## FORD E4OD "UPDATE HANDBOOK"

### INDEX

Figure 48  
AUTOMATIC TRANSMISSION SERVICE GROUP

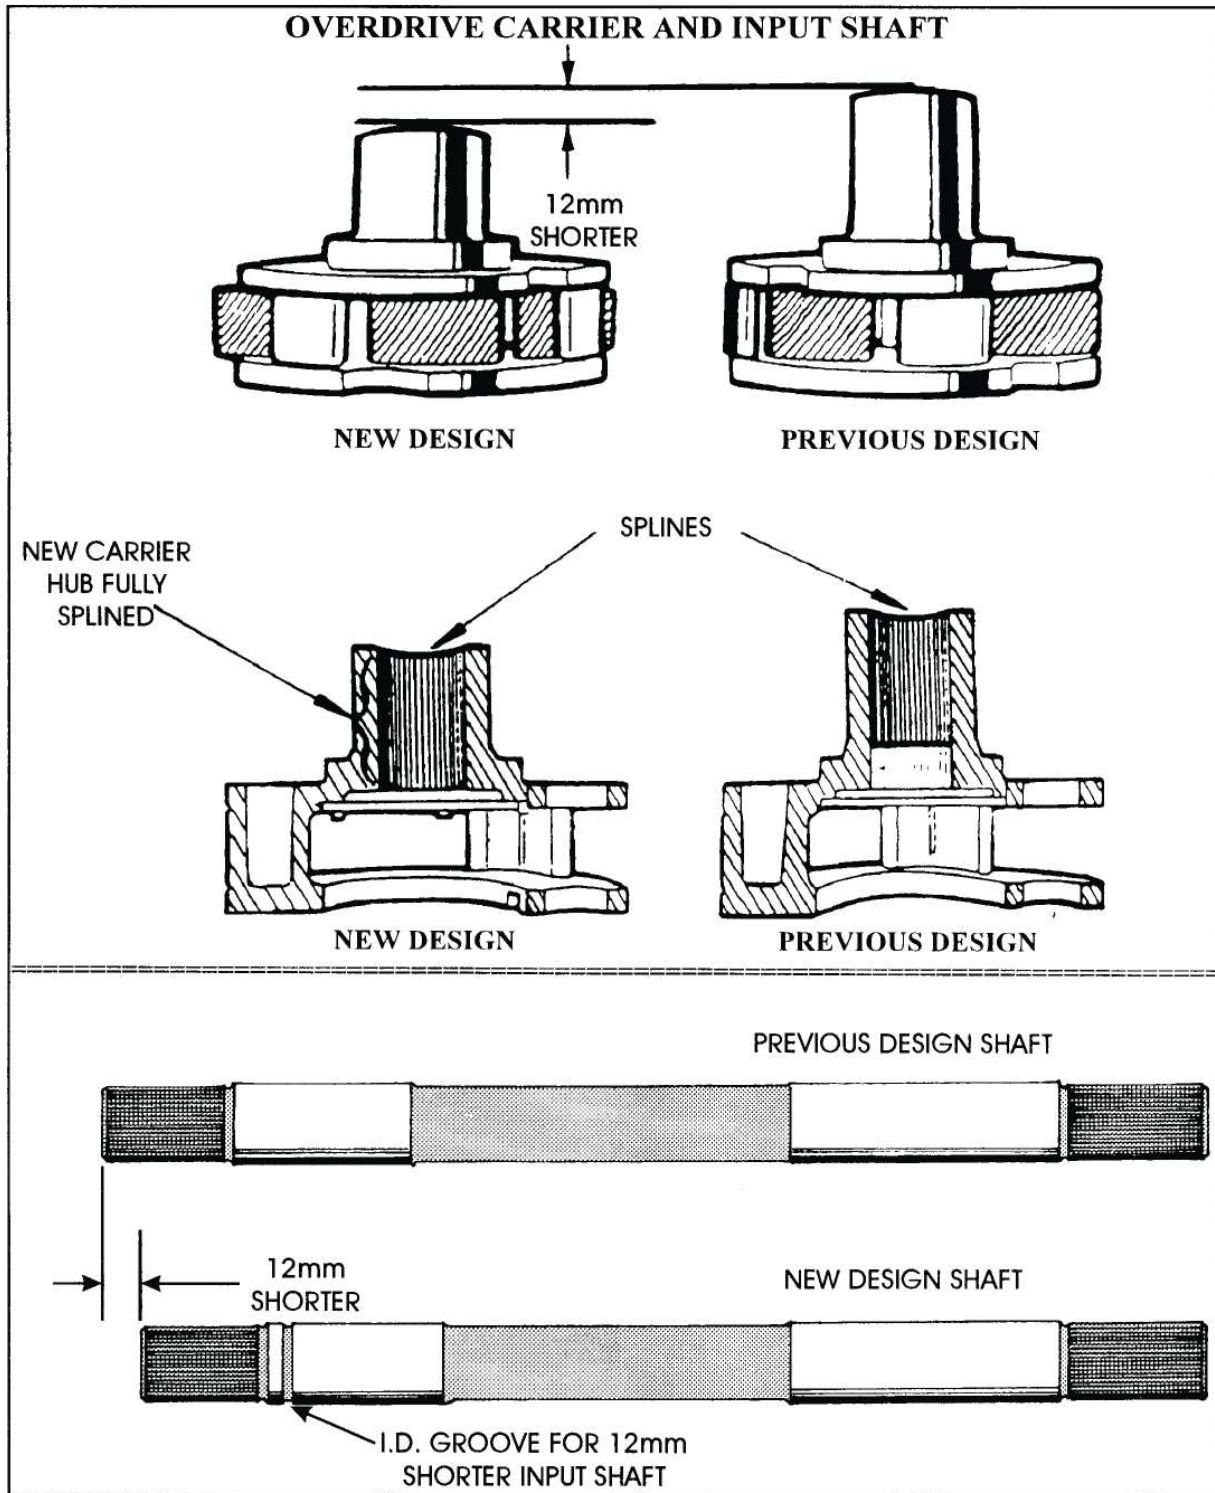
***Special Note:*** There is also an updated Overdrive Carrier and Input Shaft, available under OEM part number F4TZ-7B446-B, to help improve durability. Both pieces have different dimensions than the previous parts, as shown in Figure 48. The new overdrive carrier hub is 12mm (.472") shorter than the previous models, and the internal splines now run the full length of the hub which makes it stronger. The Input Shaft is also 12mm (.472") shorter than the previous models, to accommodate the new overdrive carrier, and has an I.D. groove cut in the shaft for identification (See Figure 48).

Figure 51

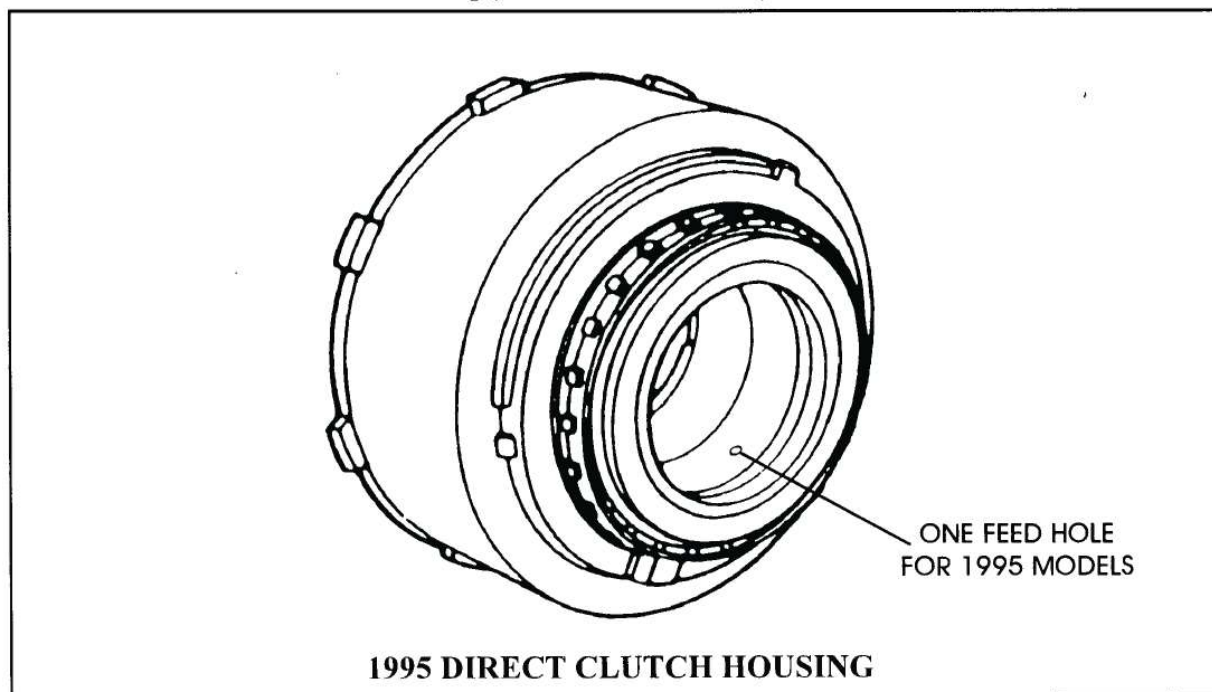
**CHANGE:** Beginning at the start of production for the 1995 model year, all E4OD transmissions were built with a revised Direct Clutch Housing (Intermediate Brake Drum) as shown in Figure 51.

- (1) DIRECT CLUTCH HOUSING - 1995 models now have only *one* direct clutch apply pressure feed hole, instead of the *two* feed holes found in previous models (See Figure 51).

Figure 52

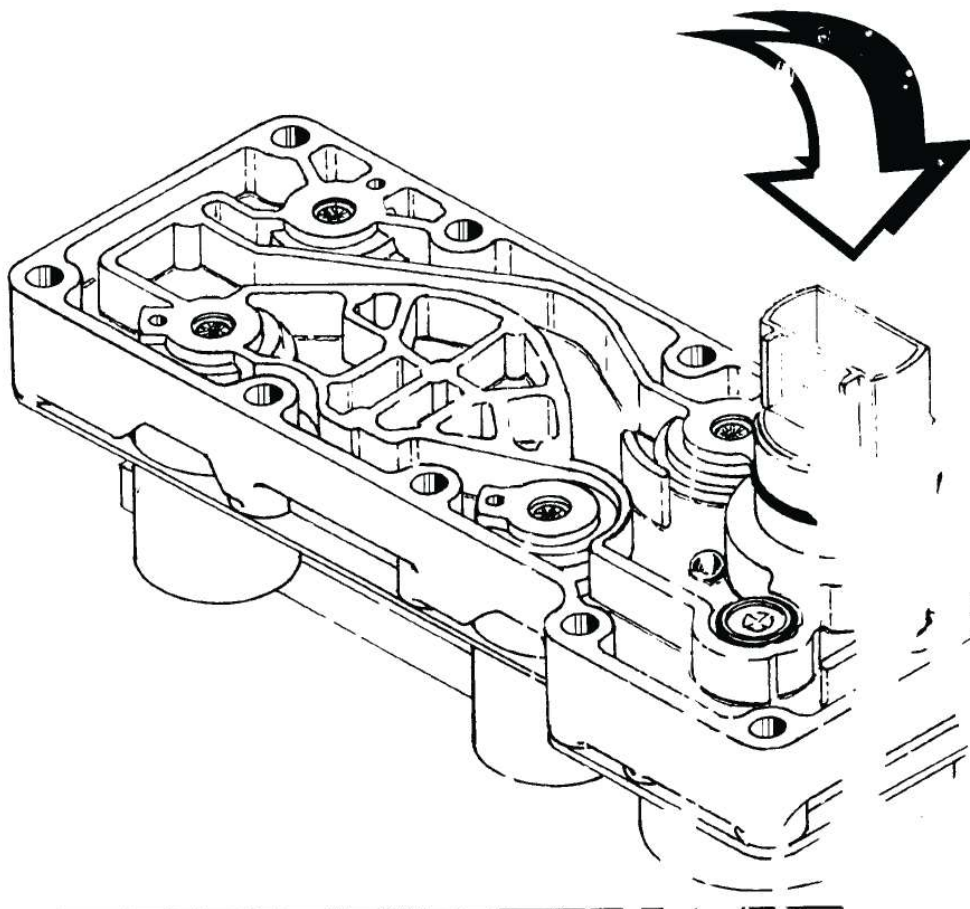
- (1) **SOLENOID PACK** - New design solenoid assembly case connector to accommodate the new design vehicle harness connector. Refer to Figure 52 for identification of the previous design and the new design solenoid assemblies.

**NOTE:** The plastic sleeve incorporated in the previous design solenoid pack has been eliminated on the new design solenoid pack (See Figures 52 and 53). This plastic sleeve will sometimes remain on the vehicle harness connector when it is disconnected. If a new solenoid pack is installed (which includes sleeve), it will be impossible to reconnect the vehicle harness to the solenoid pack until the old sleeve is removed from vehicle harness connector. Refer to Figure 53.

Figure 54

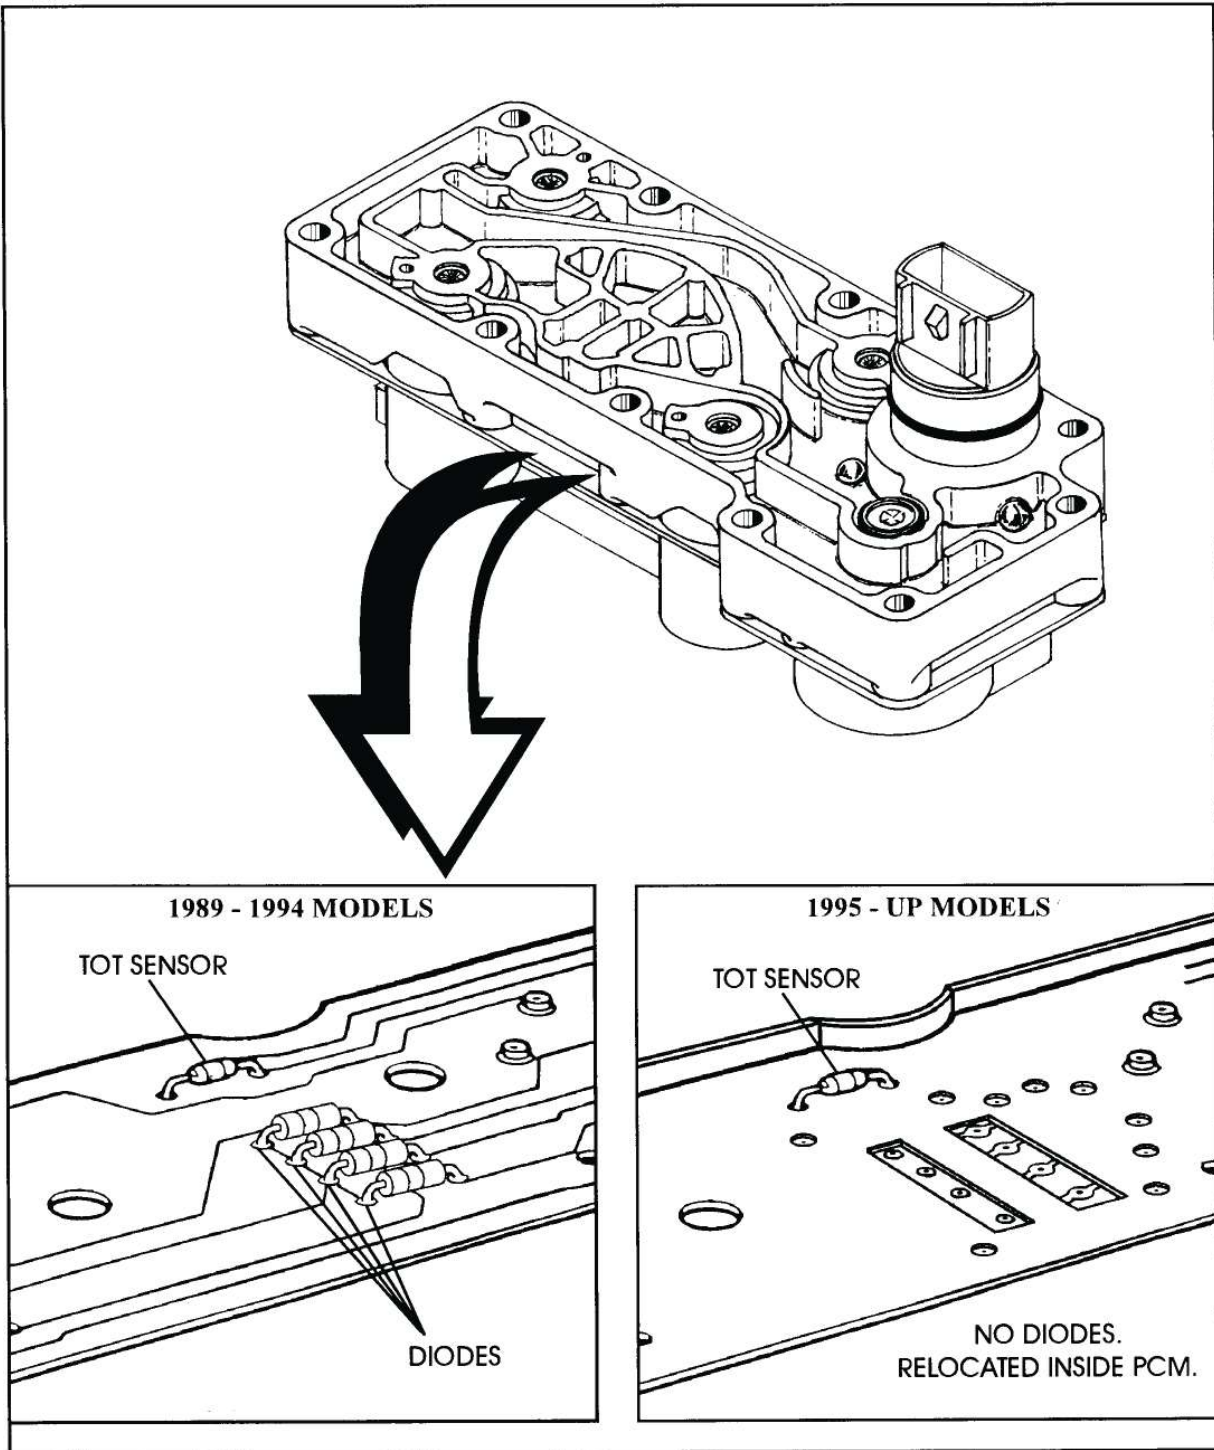
**CHANGE:** Beginning at the start of production for 1995, all models of the E4OD transmission were produced using a new design solenoid pack, that will not interchange with previous models, as the internal diodes have been eliminated and put into the PCM (See Figure 54)

*They will not interchange because in 1995 models the diodes for the solenoids were moved out of the solenoid pack and placed into the PCM (See Figure 54).*

Figure 55

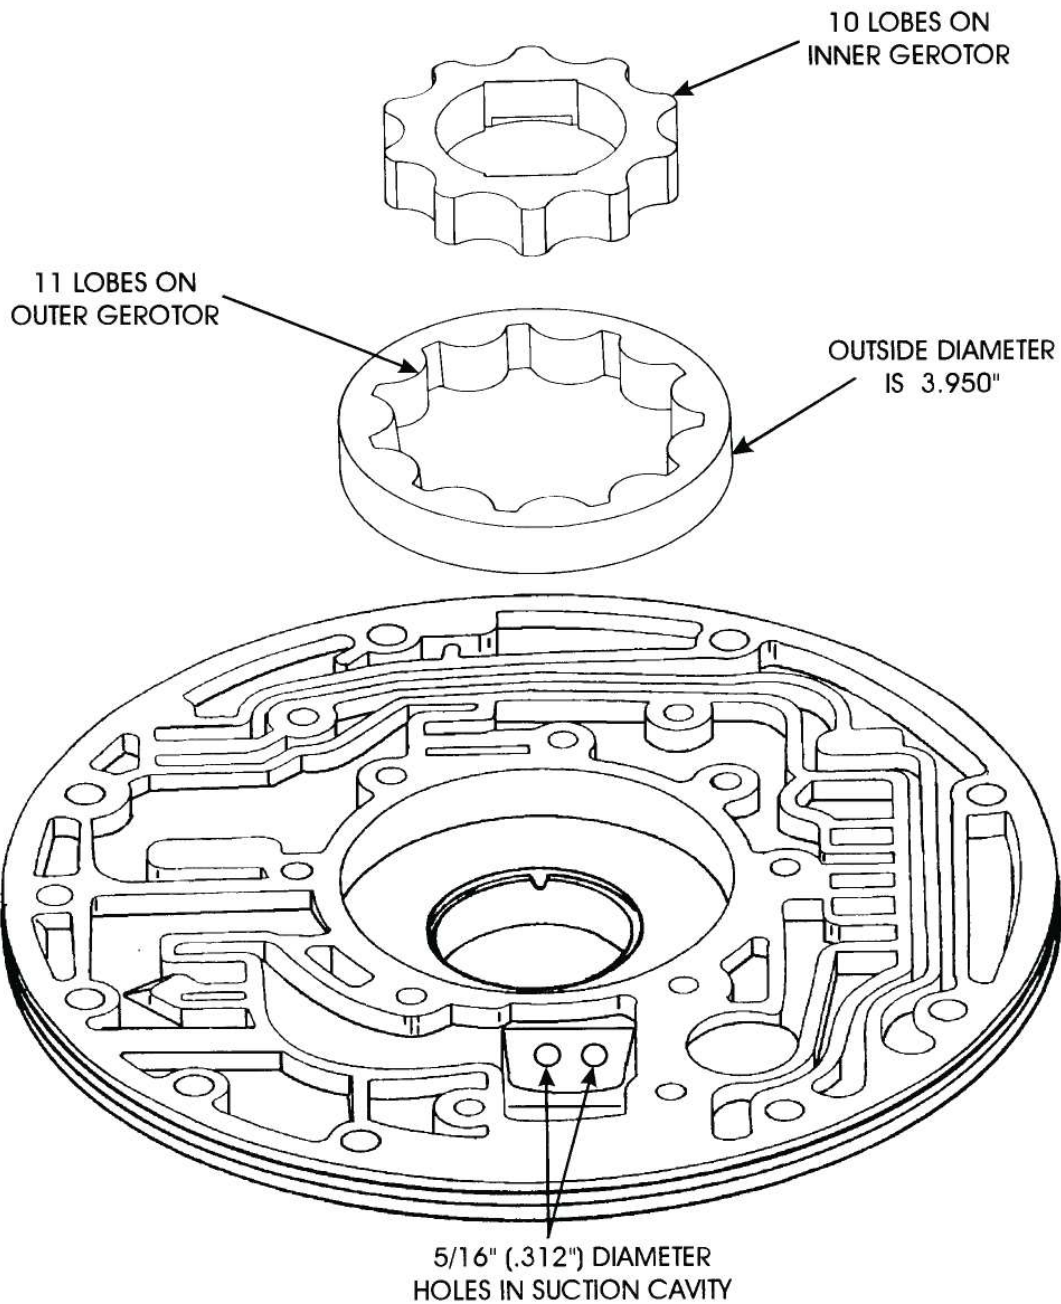
- (3) **INNER GEROTOR** - The lobes on the Inner Gerotor changed from the previous 10 lobes to 9 lobes on the new design, to accommodate the changes on the outer gerotor. Refer to Figures 55 and 56. The changes on both the inner and outer gerotor increased the cavity between the gerotors for increased pump volume, as shown in Figure 57.

Figure 57

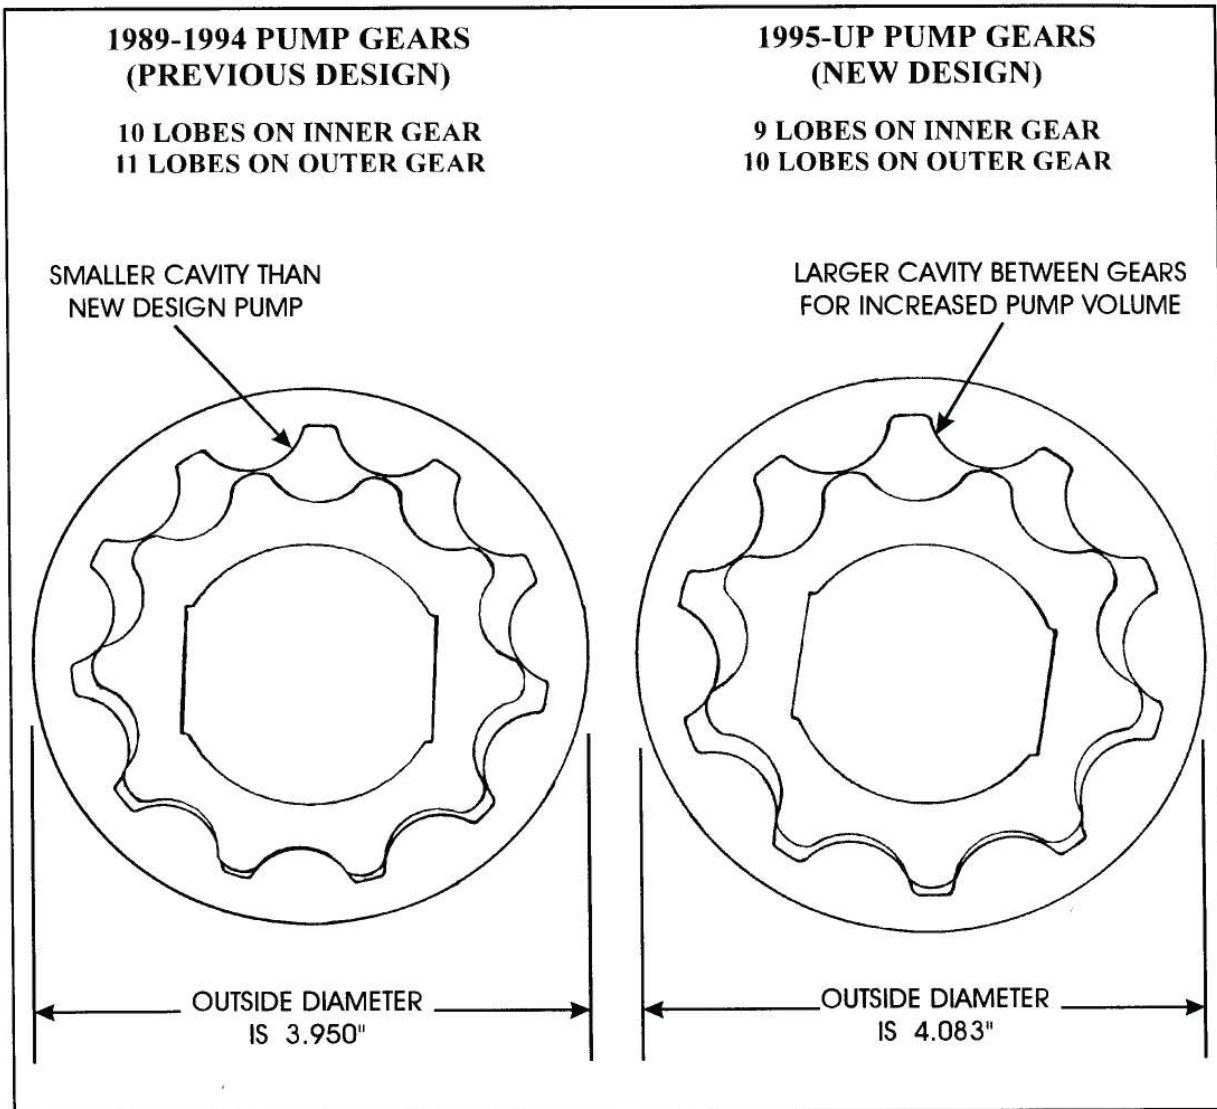
- (2) **OUTER GEROTOR** - The lobes on the Outer Gerotor changed from the previous 11 lobes to 10 lobes on the new design, to accommodate the changes on the inner gerotor. The diameter of the Outer Gerotor also changed from 3.950" to 4.083". Refer to Figures 55 and 56. The changes on both the inner and outer gerotor increased the cavity between the gerotors for increased pump volume, as shown in Figure 57.

Figure 61

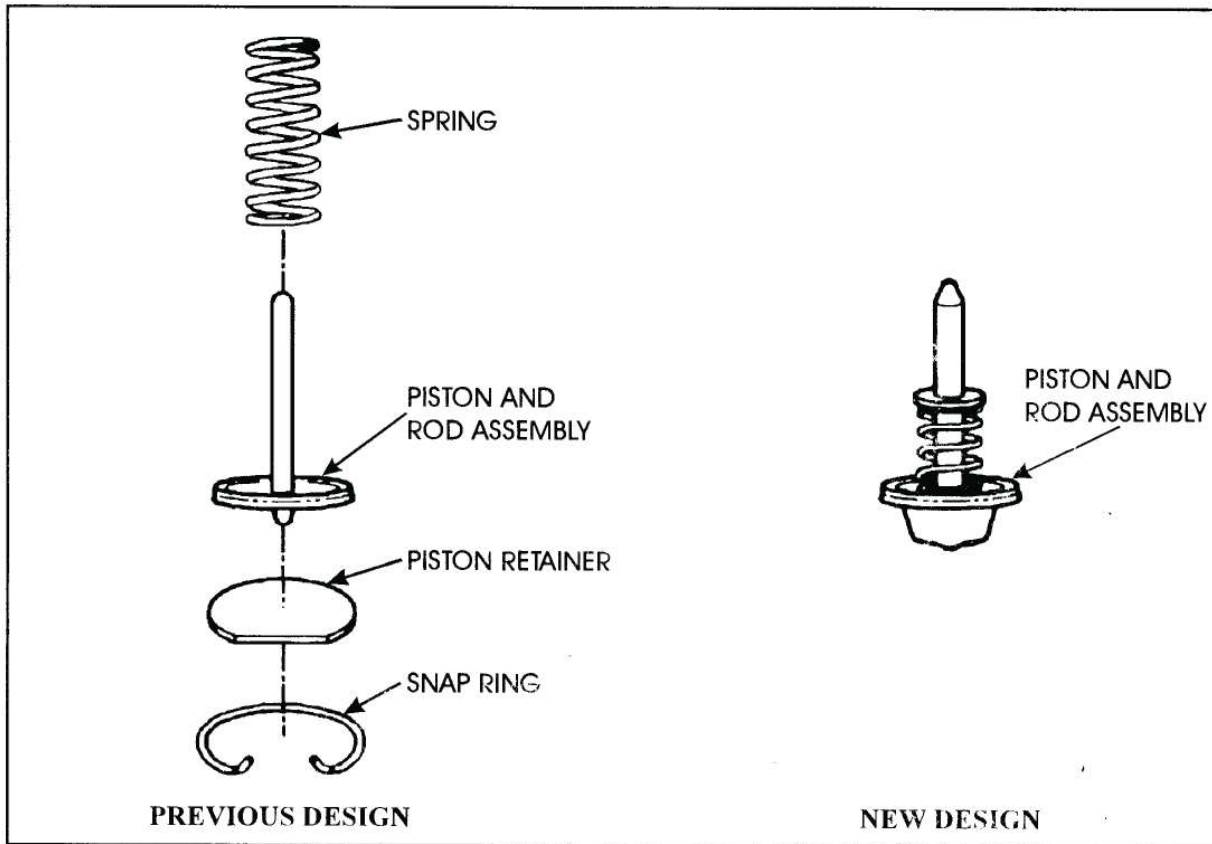
**CHANGE:** Beginning on August 8, 1995, all 1996 model E4OD transmissions were produced with a new design Intermediate Band Apply Servo Assembly (See Figure 61).

- (1) INTERMEDIATE SERVO PISTON - Total change in design, as shown in Figure 61.
- (2) SERVO PISTON RETAINER - Eliminated, as shown in Figure 61.
- (3) RETAINING SNAP RING - Eliminated, as shown in Figure 61.
- (4) TRANSMISSION CASE - Snap ring groove in the case piston bore was eliminated, as it was no longer need (See Figure 62).

Figure 63

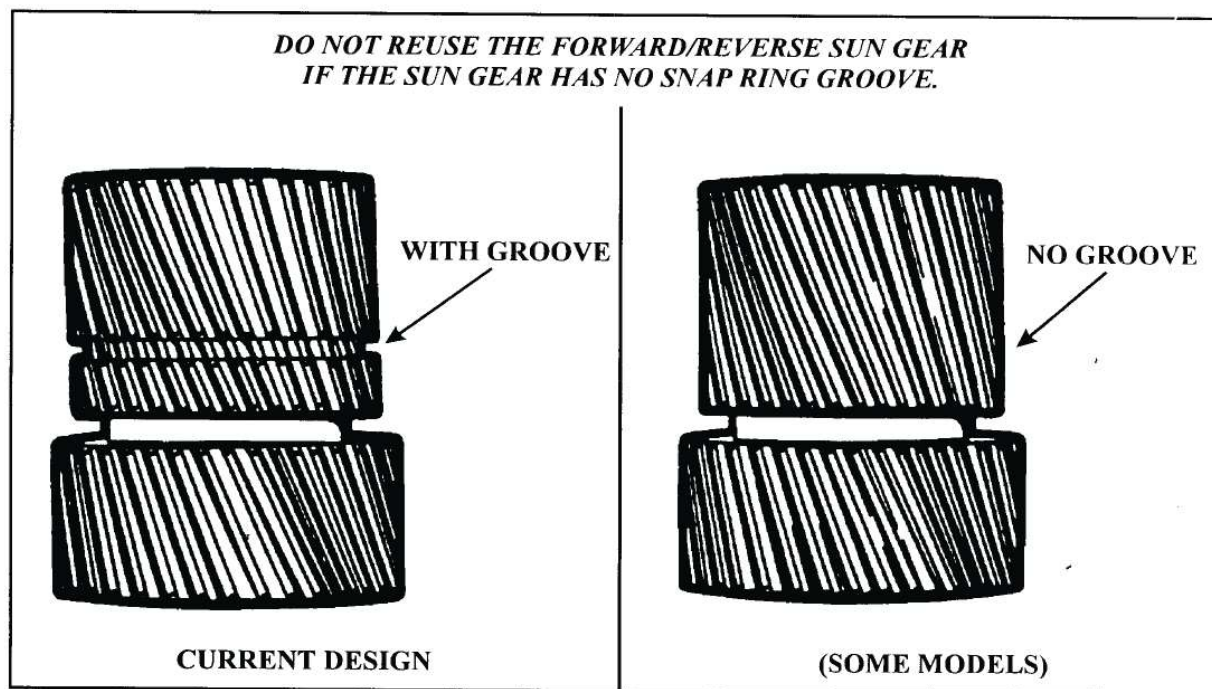
Some models of the E4OD transmission have been built with a Forward/Reverse Sun Gear that does not require a retaining snap ring, and has no groove for a snap ring, as shown in Figure 63. These transmissions are identified as model PRA-FA 12, serial number 00157935 thru 00158019.

If internal transmission repair is required for these units, replace the Forward/Reverse Sun Gear with the current service sun gear with the snap ring groove, and the snap ring (See Figure 63).

***DO NOT REUSE THE FORWARD/REVERSE SUN GEAR  
IF THE SUN GEAR HAS NO SNAP RING GROOVE.***
